# Product Advisory

<b>Product Family:</b>	Compact Limit Switches	<b>Number:</b>	PA-SENS-004
<b>Products Affected:</b>	All AEM2G Series Compact Limit Switches	<b>Date Issued:</b>	2/06/17
<b>Subject:</b>	Modification to how the switch head attaches to the switch base	<b>Revision:</b>	Original

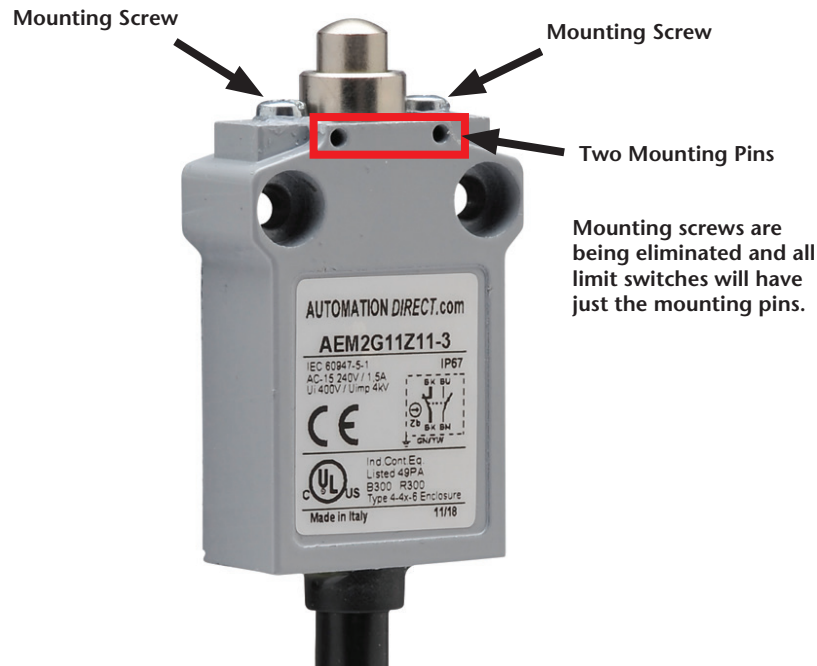
Currently there are two methods to secure the switch head to the switch base:

1. Some version have two mounting screws, as shown below.
2. Other versions have two mounting pins, also as shown below.

The manufacturer has modified these limit switches so that all of them will have just the two mounting pins. The mounting screws are being discontinued.

The modified limit switches are being introduced as a running change, so it will take awhile to deplete our inventory of the older stock. Until they are all sold you may receive limit switches that still have the mounting screws.
